LAKE PONTCHARTRAIN, LOUISIANA AND VICINITY

BAYOU BIENVENUE  
CONTROL STRUCTURE

PERIODIC INSPECTION REPORT NO. 2

LMVED-G (NOD 30 Nov 79) 1st Ind  
SUBJECT: Lake Pontchartrain, Louisiana and Vicinity, Chalmette Area  
Plan; Bayou Bienvenue Control Structure, Periodic Inspec-  
tion Report No. 2, July 1979

LAKE PONTCHARTRAIN LA AND VICINITY  
 CHALMETTE AREA  
 BAYOU BIENVENUE CONTROL STRUCTURE  
**CHANNEL SCOUR SURVEY**  
**PLAN AND PROFILE**  
 U.S. ARMY ENGINEER DISTRICT, NEW ORLEANS  
 CORPS OF ENGINEERS  
 FILE NO. M-4 2685

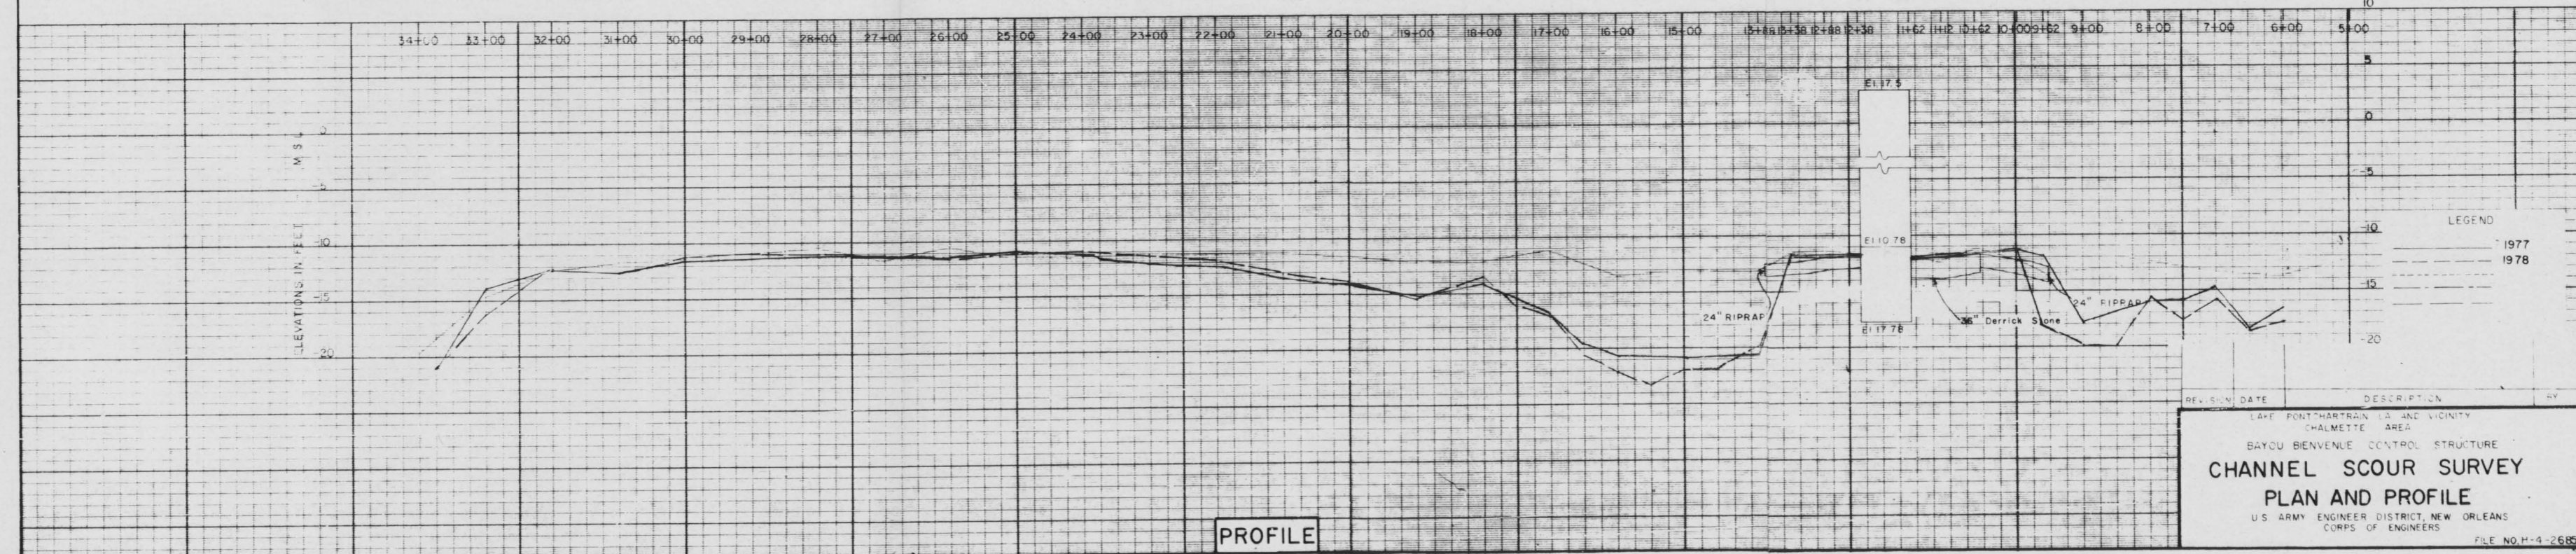
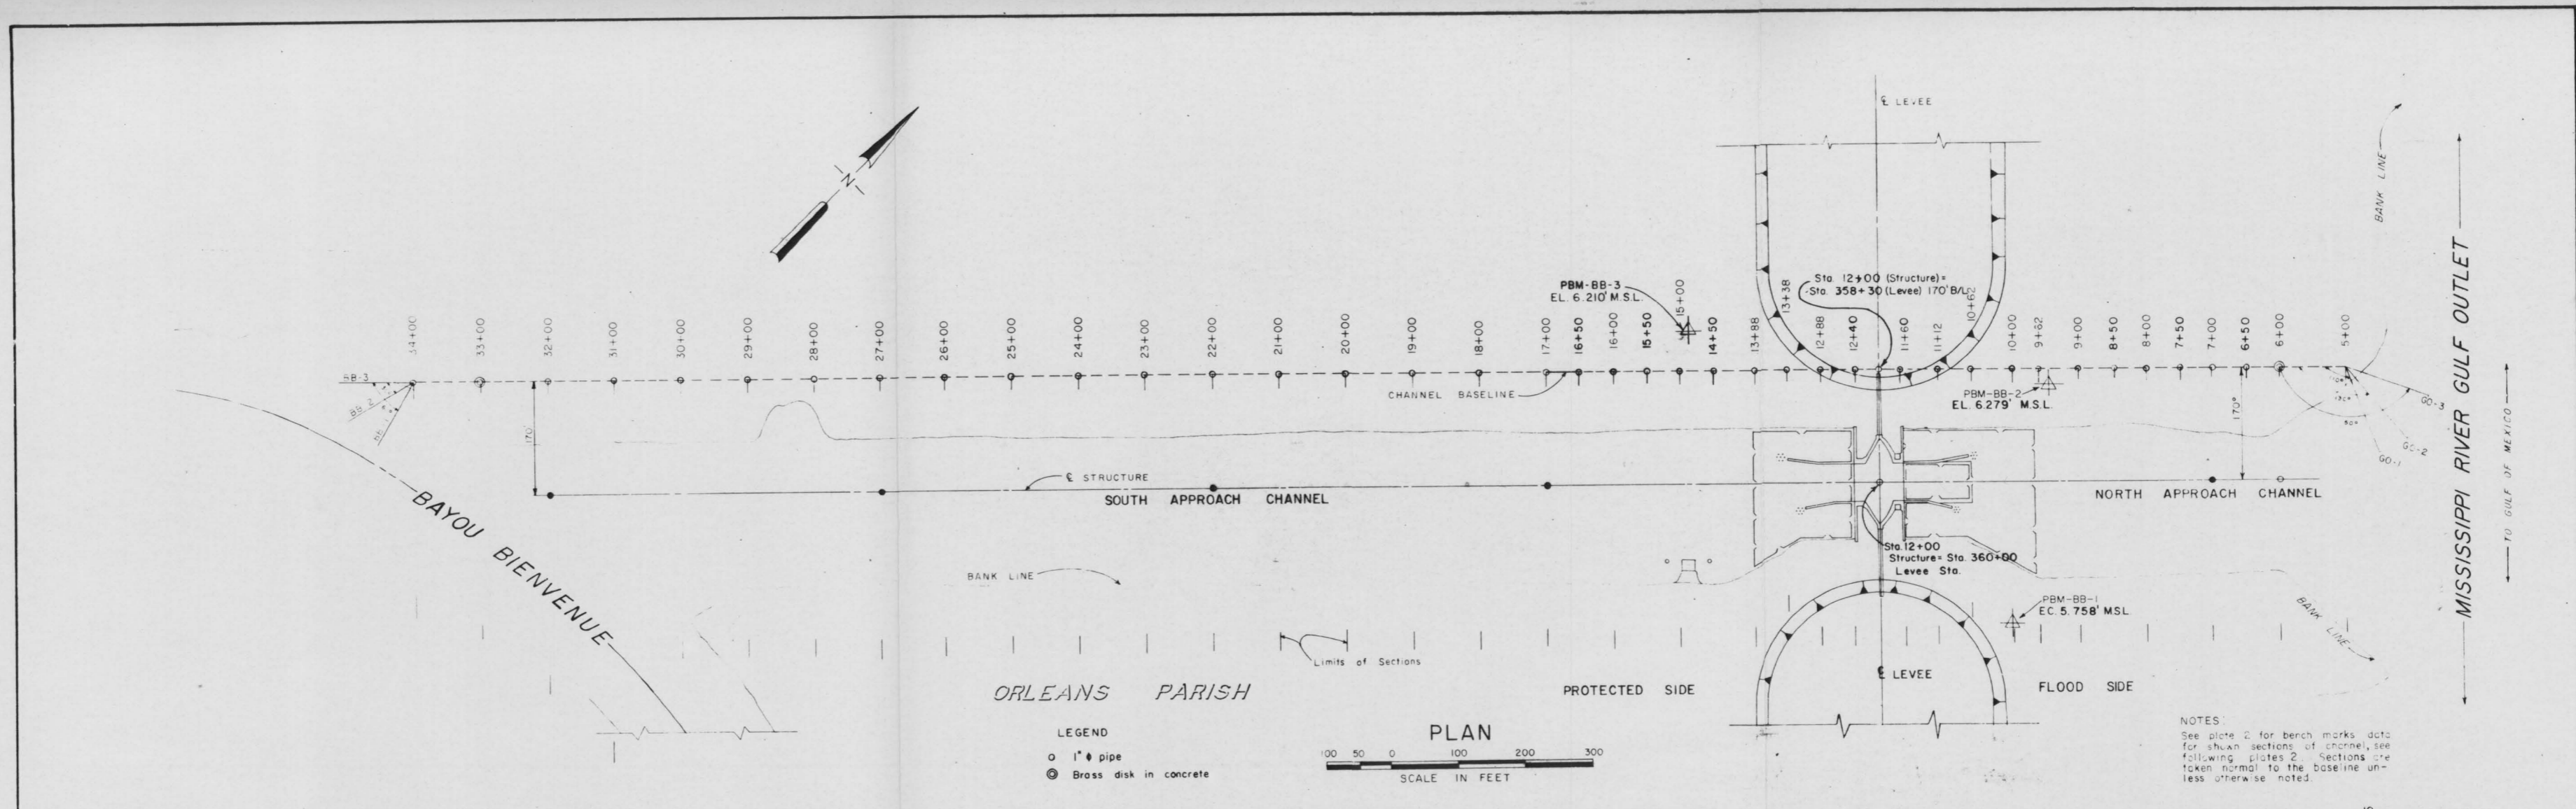
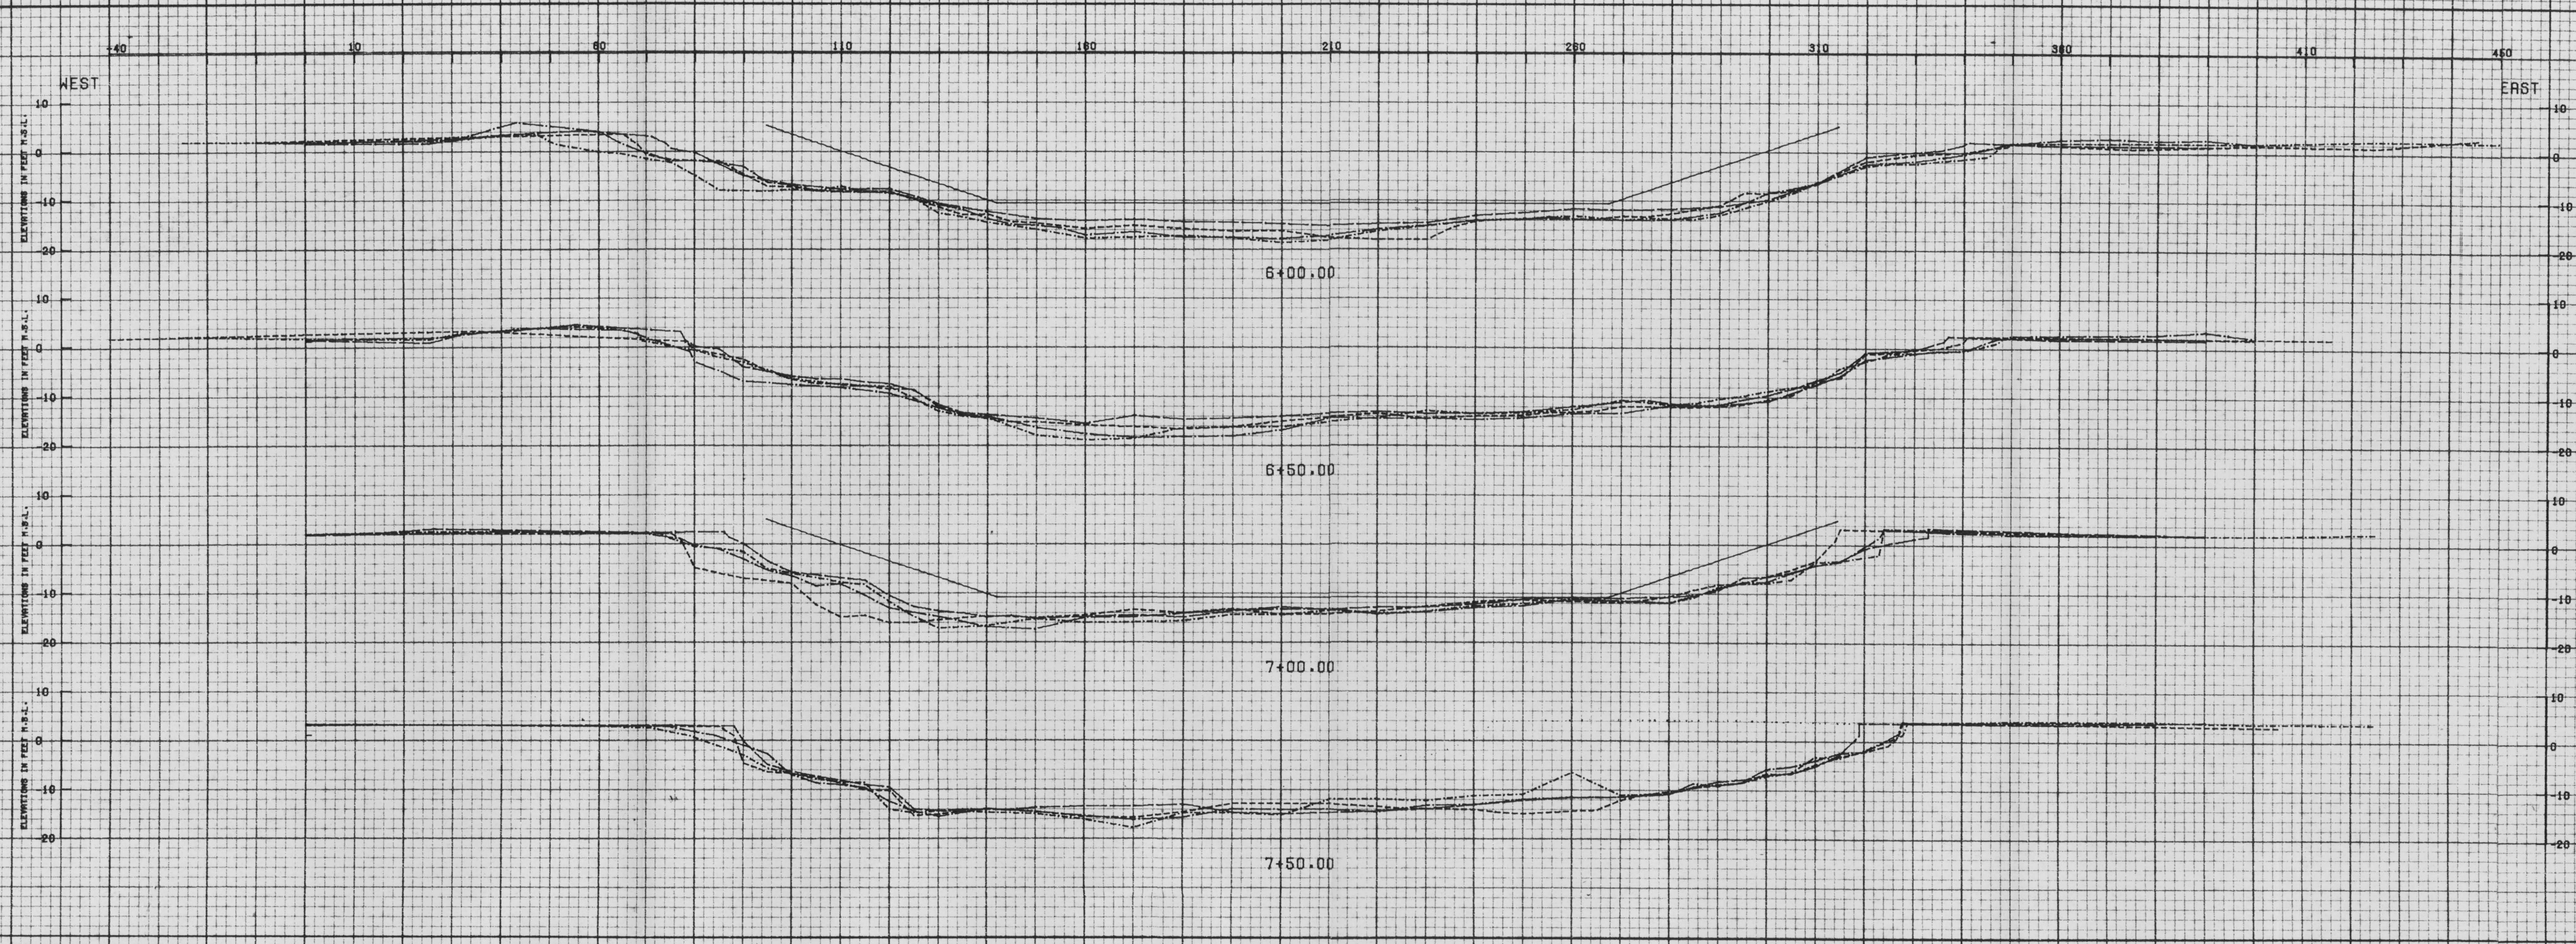
b. Para 6-02c, page VI-1. The scour surveys shown on plan and  
profile sheets on Plates 5 and 6 and also on the cross-sections on  
Plates 7 through 15 indicate considerable scouring is occurring from  
year to year in the vicinity of the structure. Although this scour is  
not presently endangering the integrity of the structure, repair work  
should be scheduled and performed within the next calendar year. This  
repair work should consist of a layer of riprap of sufficient size and  
gradation to preclude a similar scour problem in this area in the future.

BAYOU BIENVENUE CONTROL STRUCTURE  
CRACK SURVEY - DECEMBER, '73

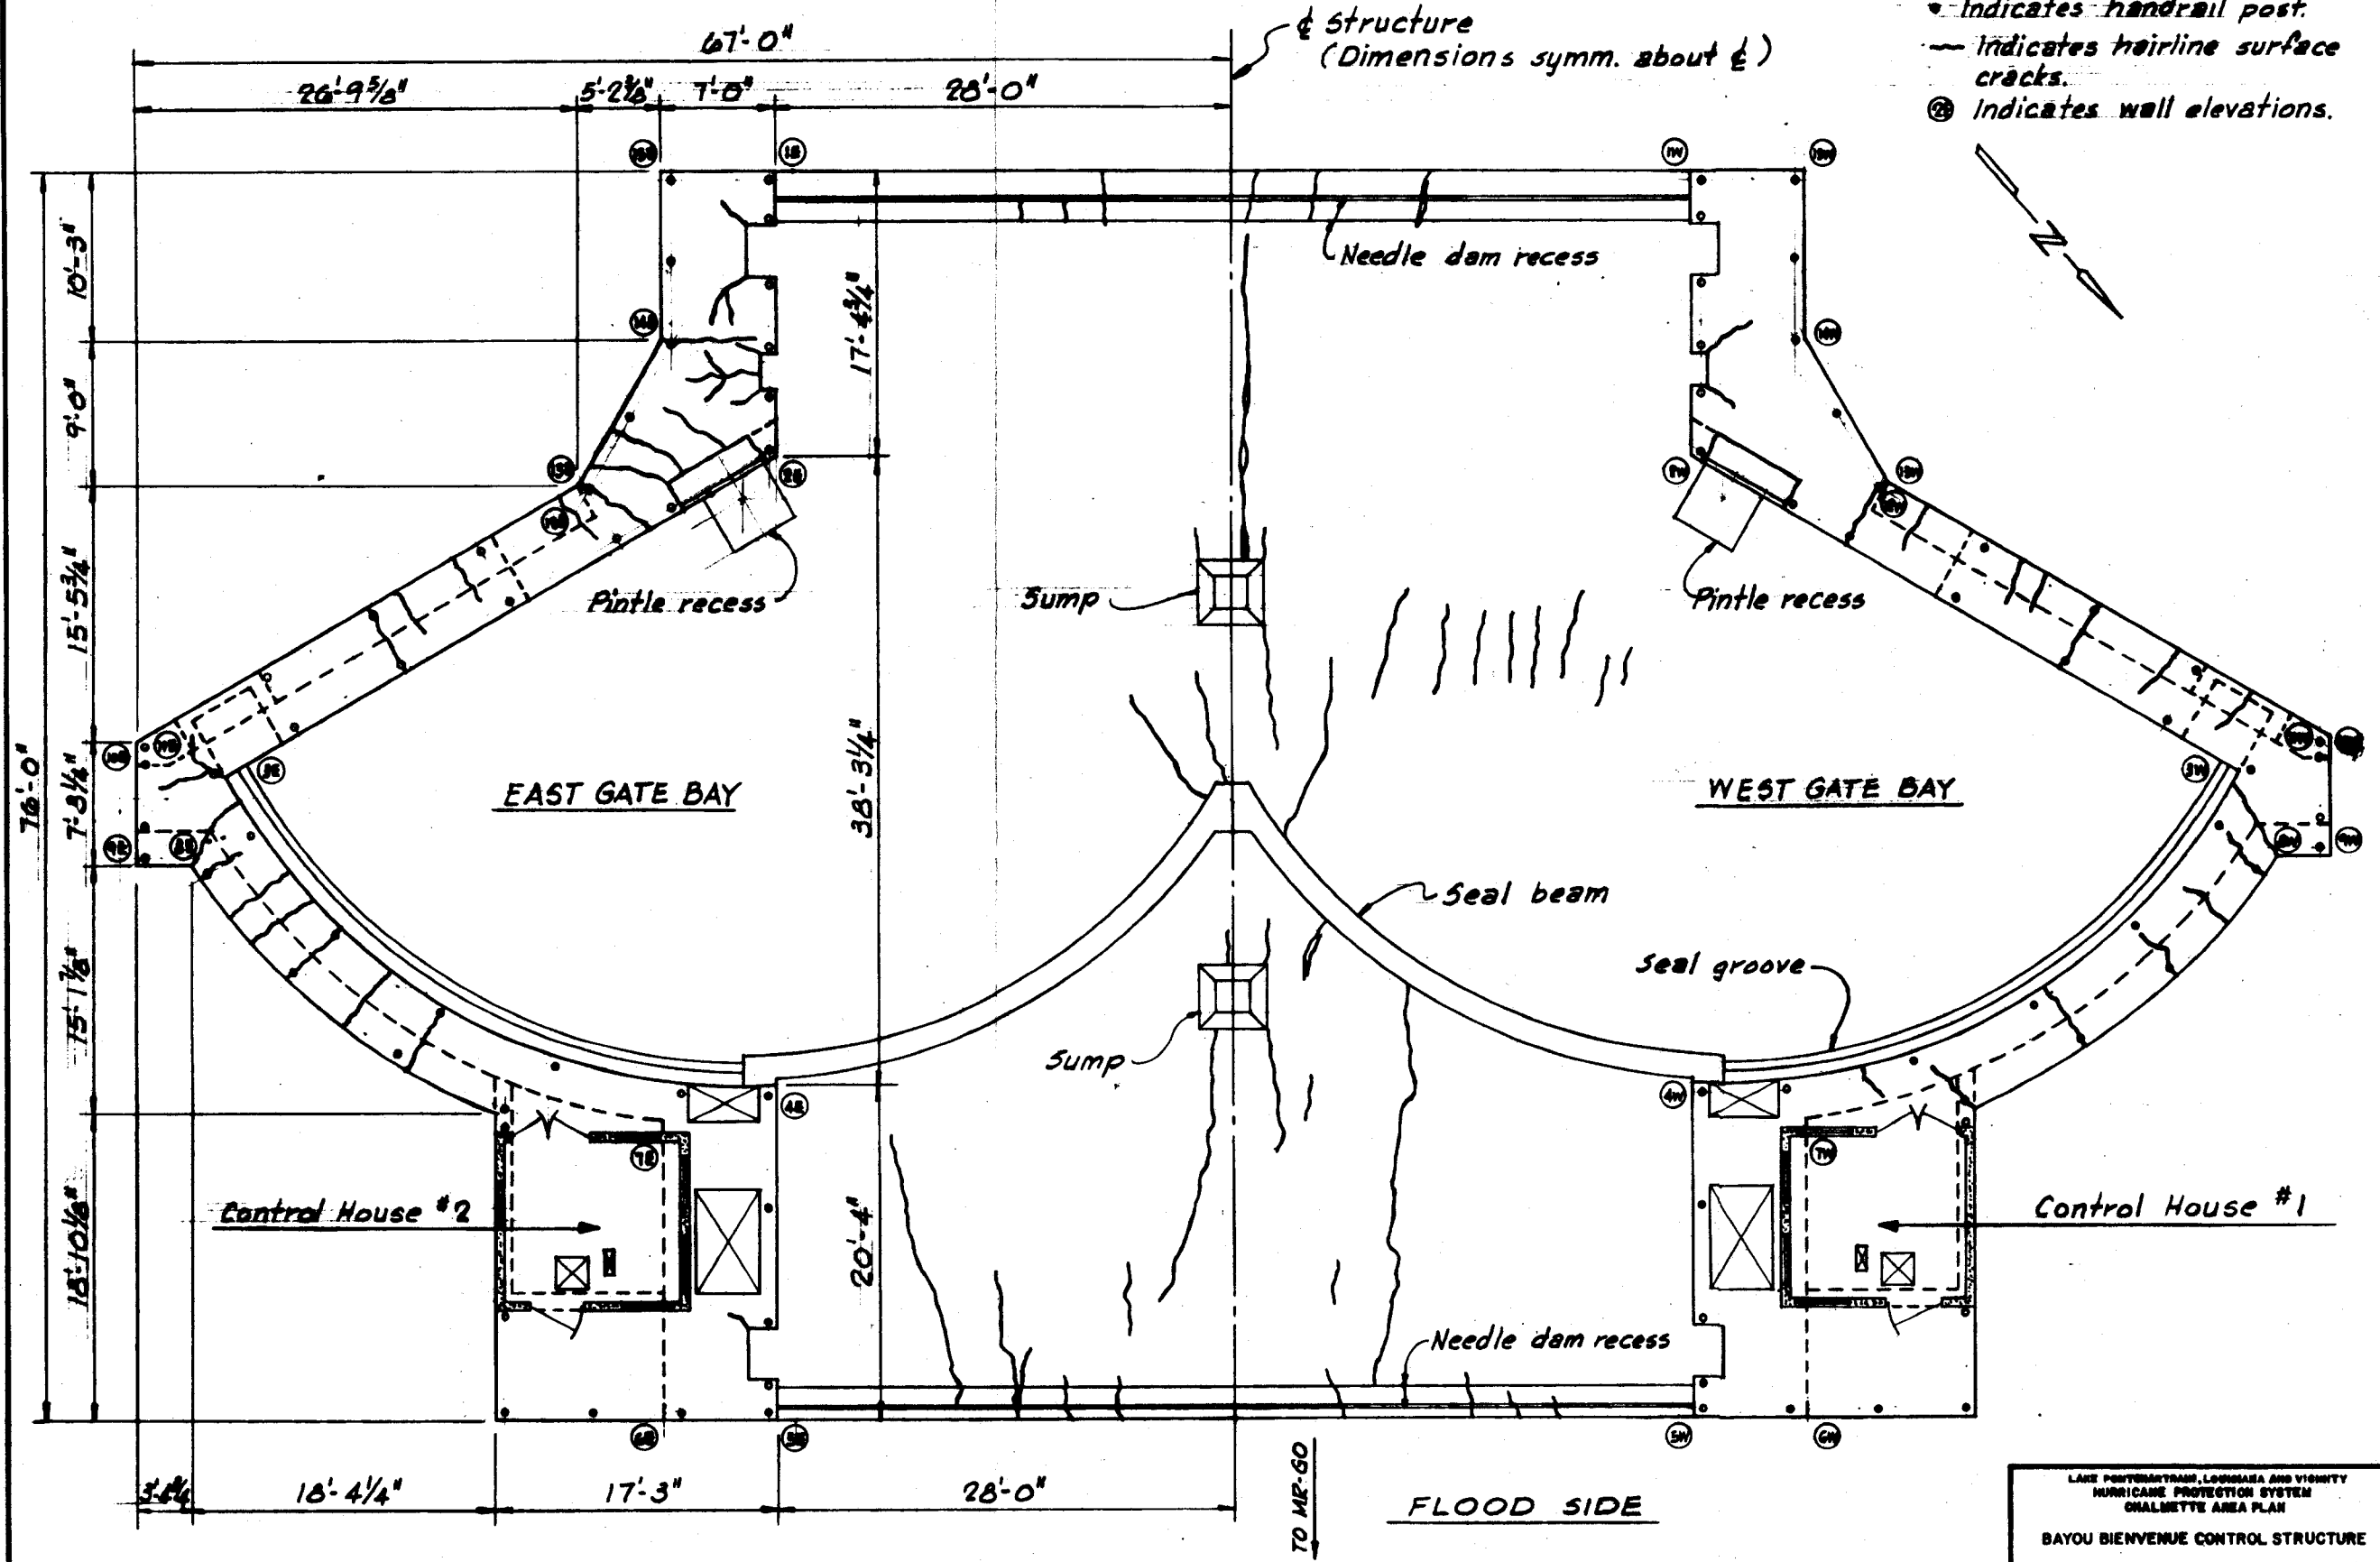
c. Refer to minor corrections in red on page VI-1, Plate 27, and  
Photographs No. 5 and 6.

2. This report need not be resubmitted. Minor corrections referenced  
in para 1c above should be made in your file copies of the report.
